Subject: Request for 5010 Post Inspection Written Response

RE: Michael J. Smith Field (MRH)
5010 Airport Data Collection Program

The physical inspection of the airport was conducted for updating the Federal Aviation Administration's Airport Master Record for Michael J. Smith Field and enclosed is a marked-up version of the 5010 form, showing the changes submitted to the FAA. With regard to the FAA criteria for the airport, please note the following:

Concrete Base Lip

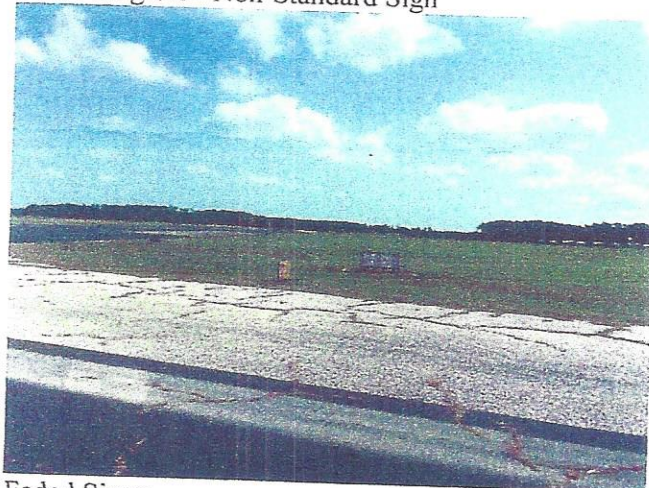
- As noted in the general comments below, all concrete bases should be at grade.
- Between Runway 26 and Taxiway B there are concrete dams which are a potential safety hazard.

- All concrete bases, whether for signs, ducts, NAVAIDS, or lighting should be at grade.
- The taxiway from Runway 14 to Runway 8/26 has failing pavement and vegetation in cracks.
- Only Taxiway B is identified with signs. The other taxiways are not labeled.
- There are many non-standard signs in taxiway and runway safety areas. There are some non-standard signs on metal (non-frangible) posts in the vicinity of the hangars.
- The supplemental windsock was faded.
- The beacon could not be checked at the time of inspection.

Runway 32 Threshold Bar

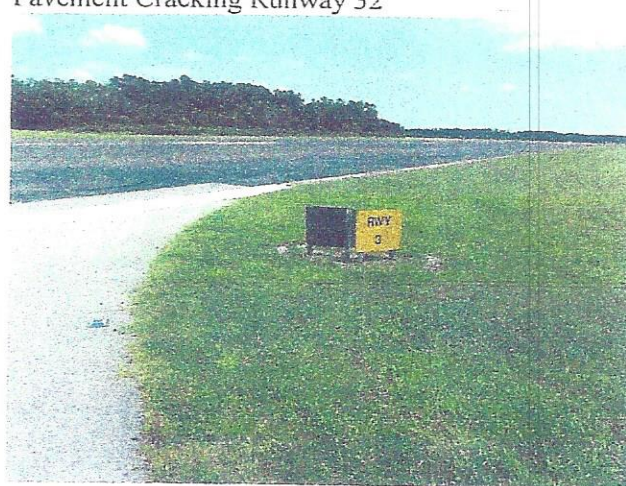
- Runway 14/32 has block cracking, pavement cracks and holes with vegetation and grass encroaching on the pavement ends.
- The aggregate is beginning to become loose and there is some F.O.D.

- The markings are faded.
- The number markings for Runway 14 are not positioned in accordance with AC 150/5340 (a portion of the AC is included).
- No PK Nail was located at the beginning of Runway 32.
